ADDENDUM NO. 1

Job No. F70C616E
SAND ISLAND STATE RECREATION AREA
SEWER SYSTEM IMPROVEMENTS
PHASE 2: PUMP STATION 3 RELOCATION & FM 3 REPLACEMENT
Honolulu, Oahu, Hawaii

02/22/21

| 1 | ADDENDUM NO. 1: NEW SHEET | 20 of 25 | 2/19/2021 | | |
|--|---------------------------|-------------|-----------|------|----------|
| APPROVED: | | DRAWING NO. | C020A | | |

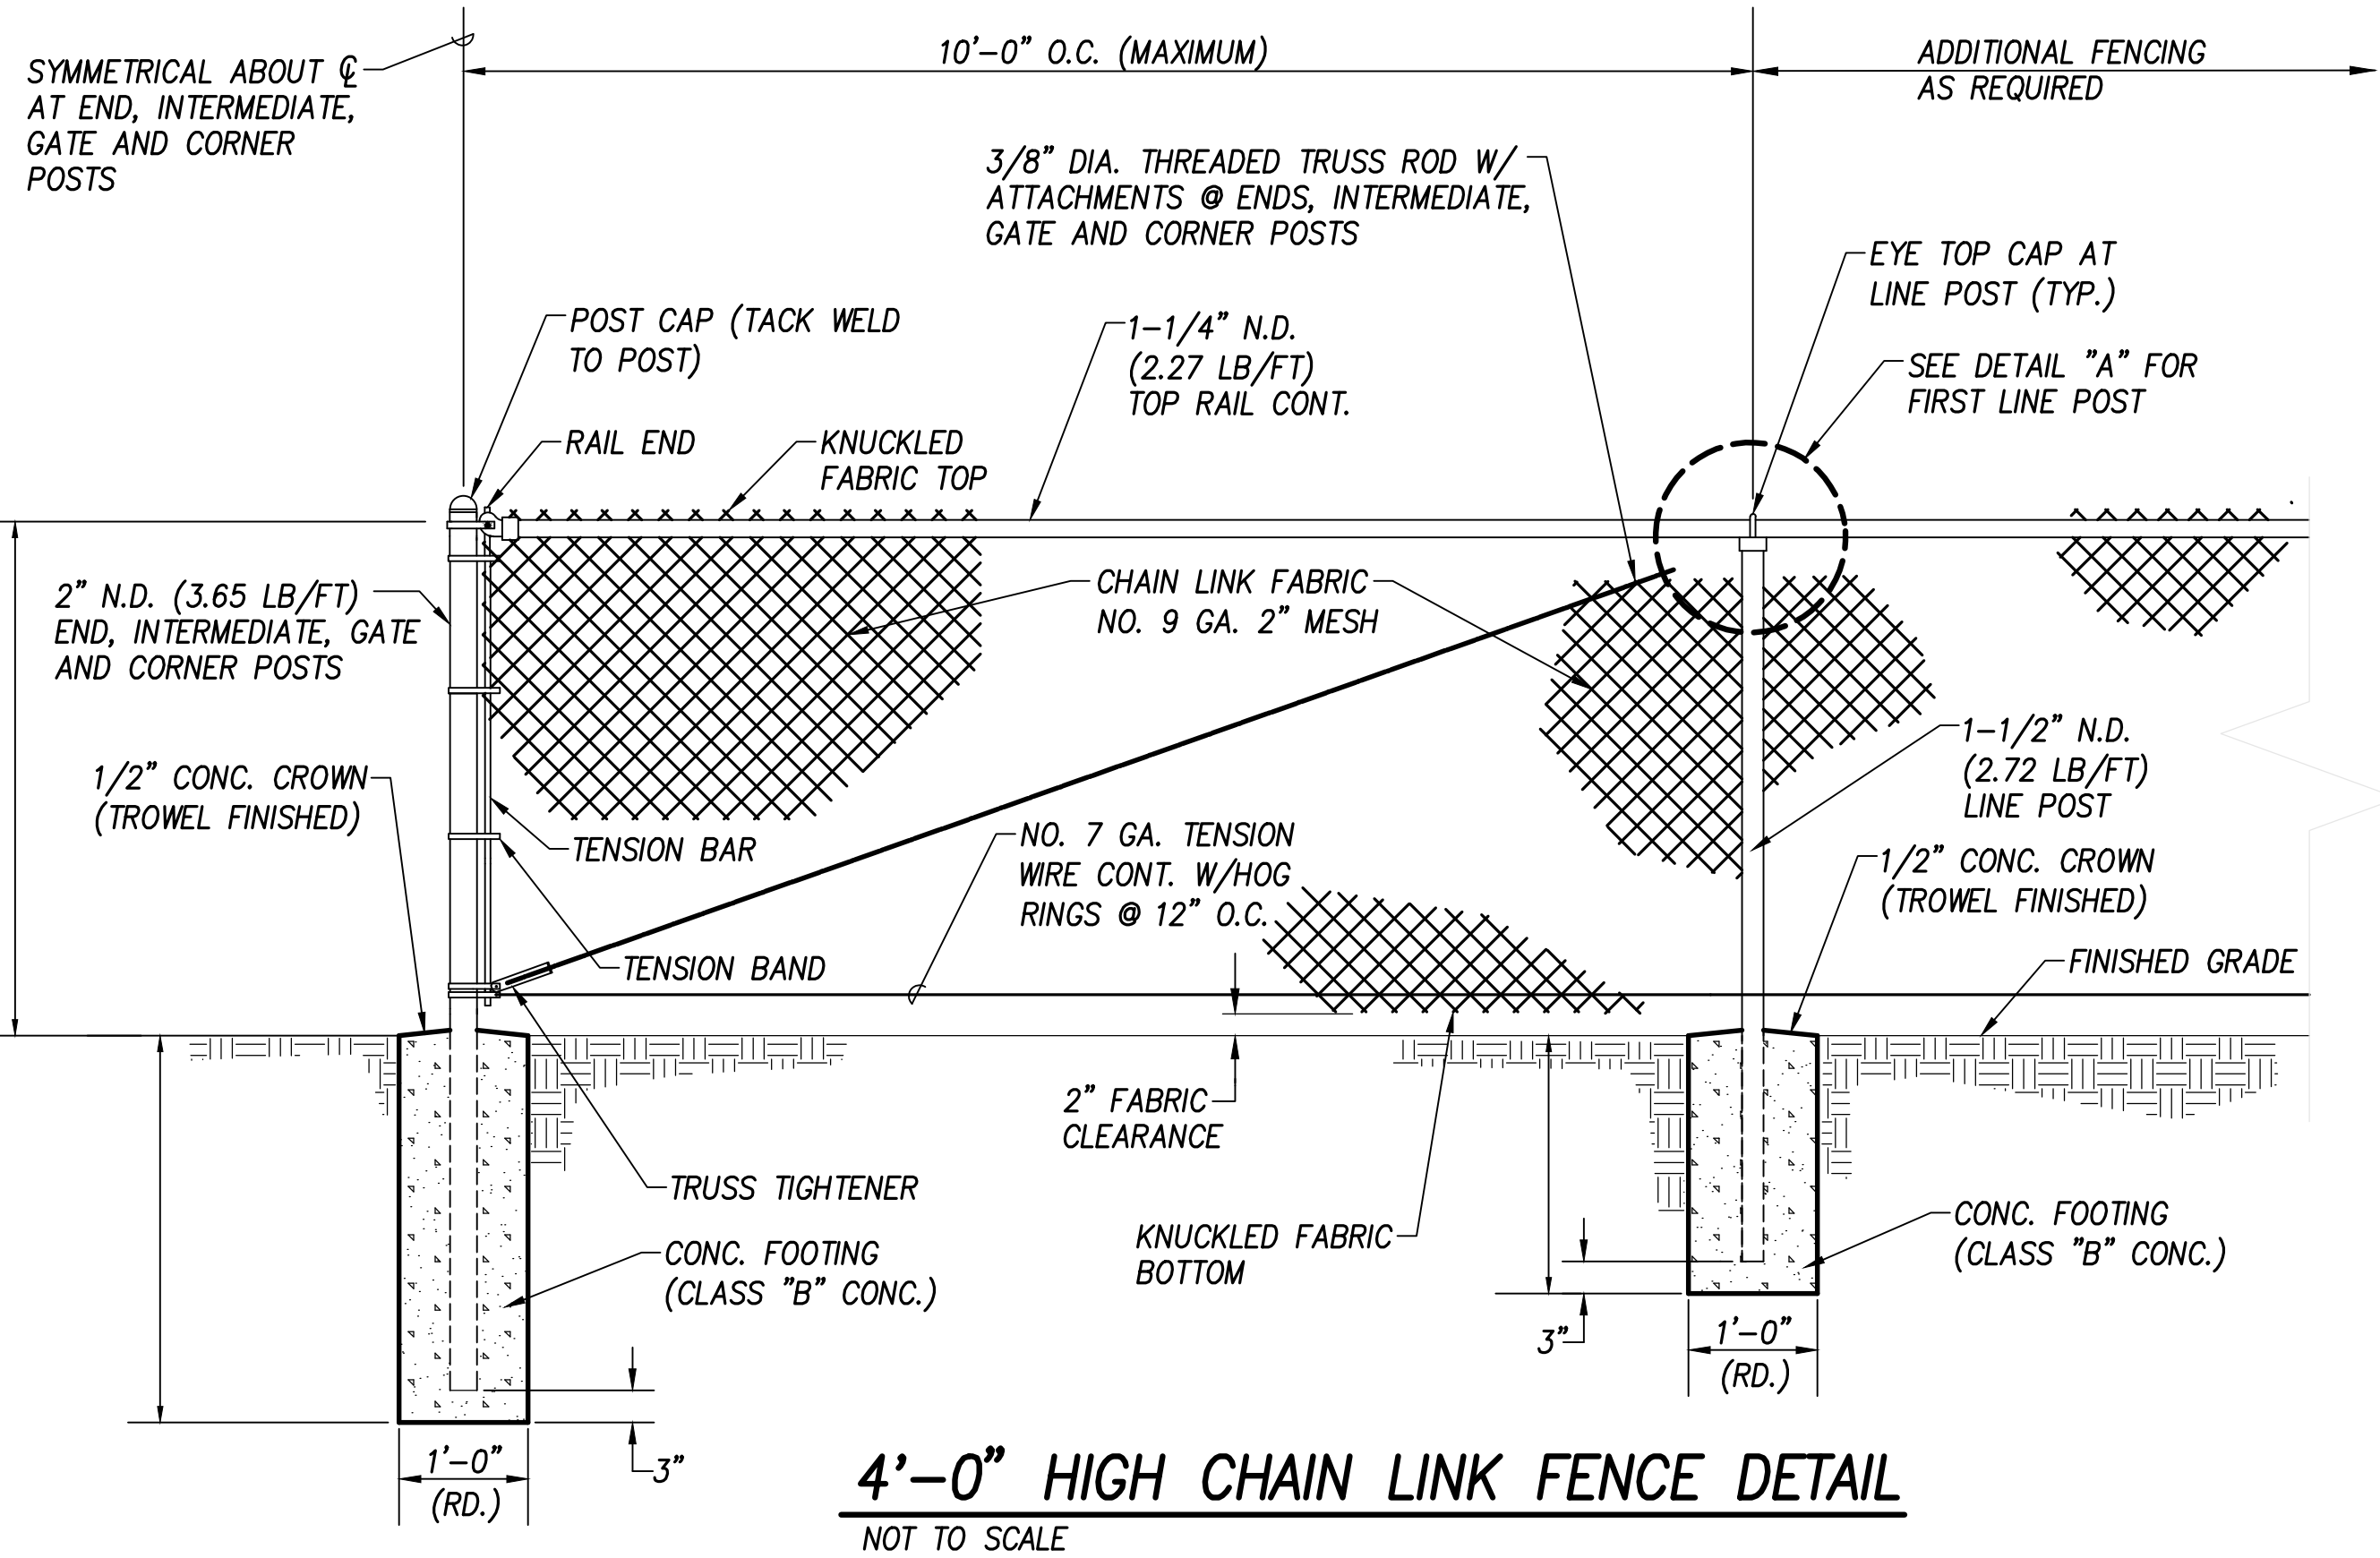
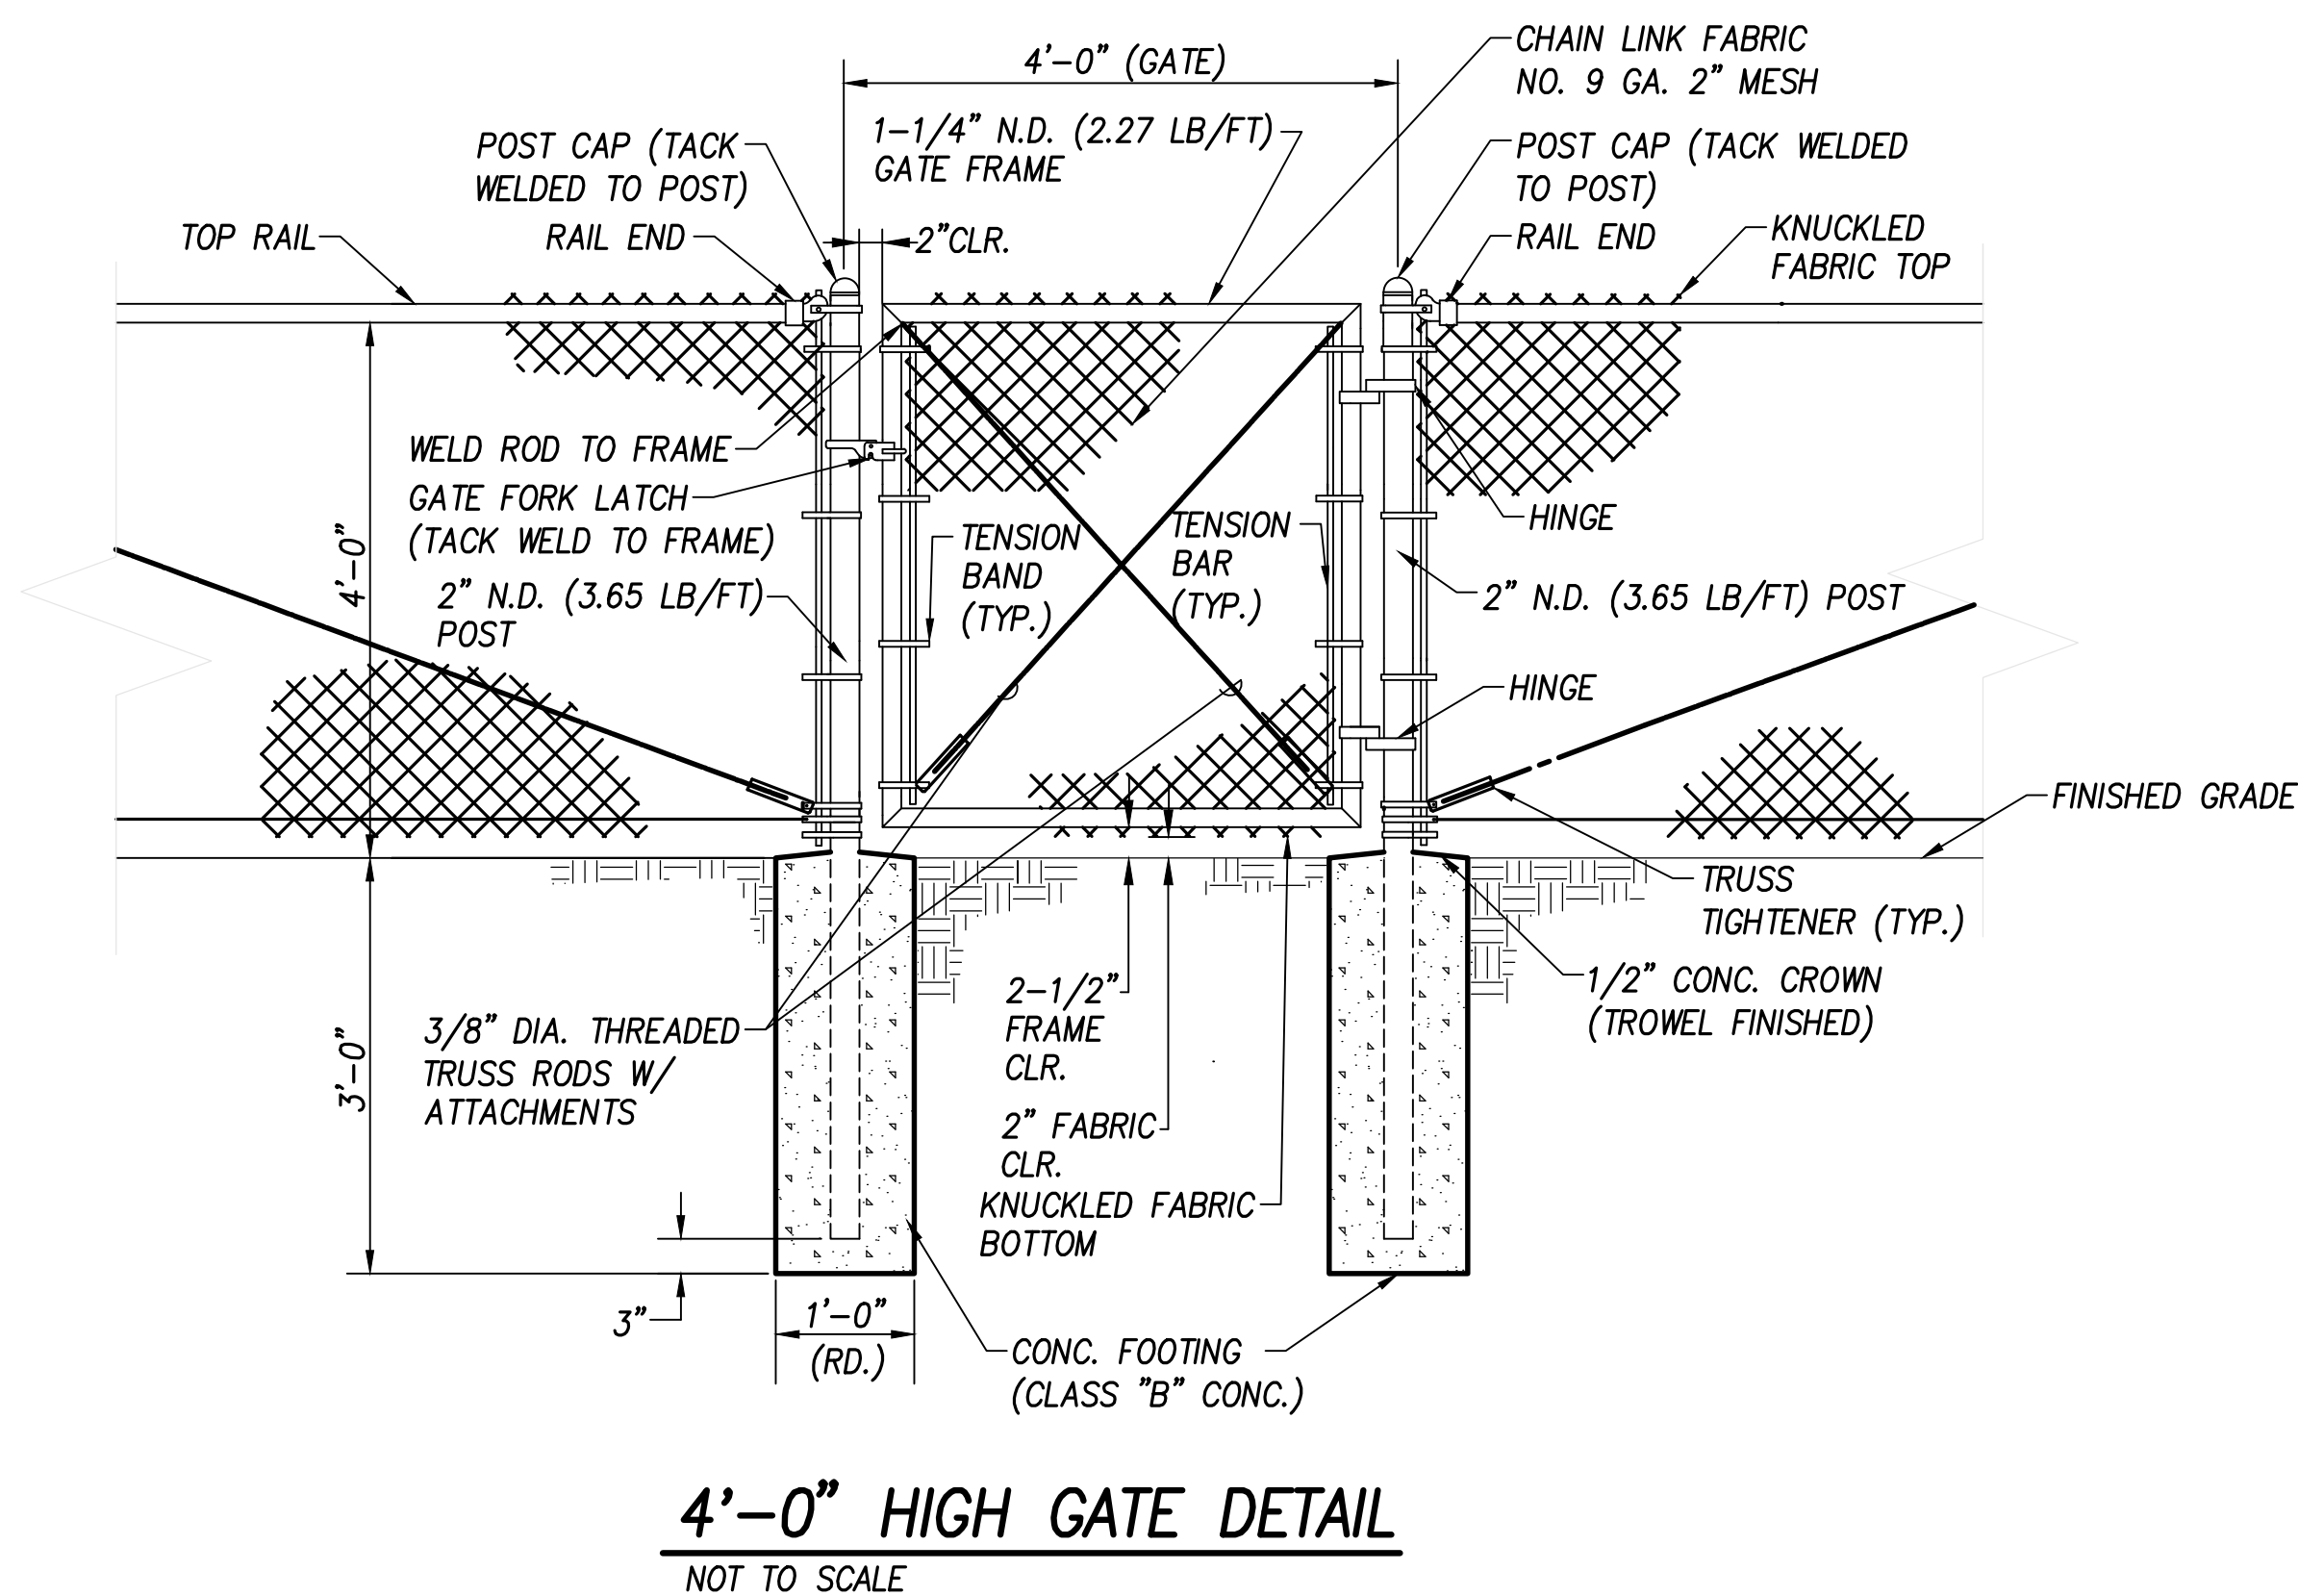
12. Please provide a detail for new chain link fence.

Answer: See new Drawing No. C020A in this addendum.

| APPROVED: | DRAWING NO. E-4 | |

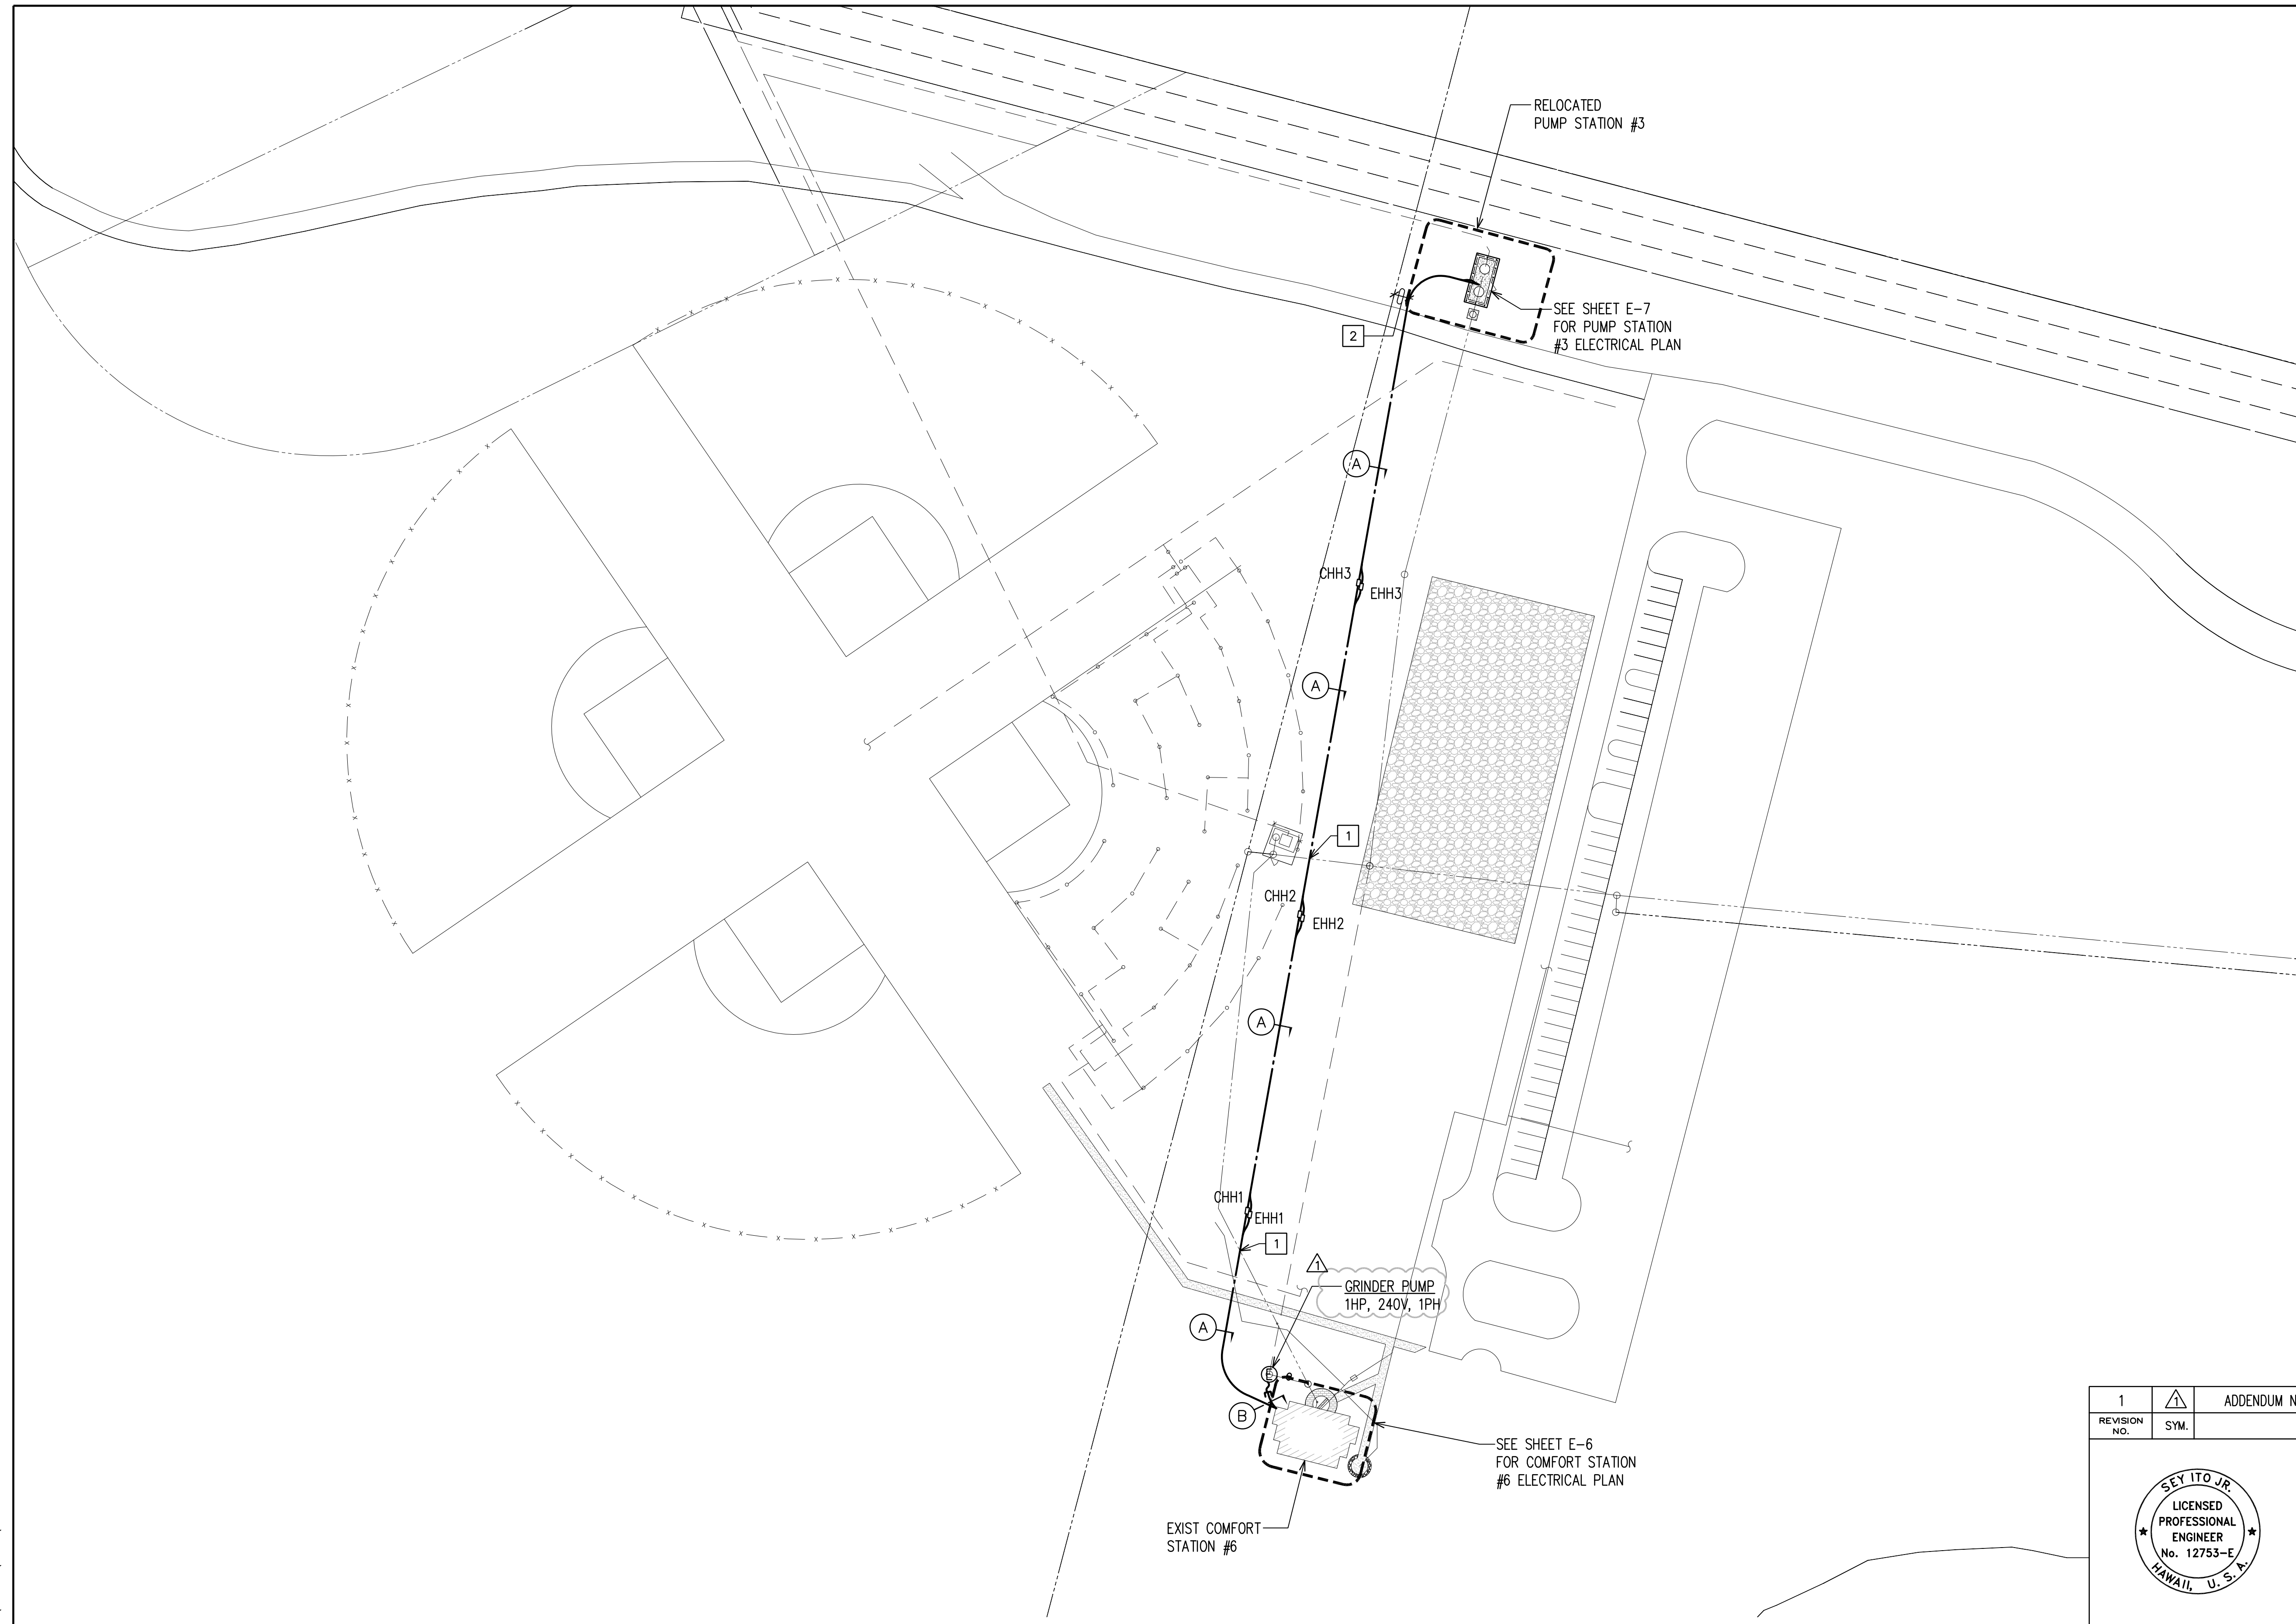
- b. Added note to reference sheet C005A for phasing plan.
- 16. Sheet E-4, “New Electrical Site Plan”:
 - a. Revised grinder pump electrical rating.
 - b. Removed hazardous classified location box note 3.
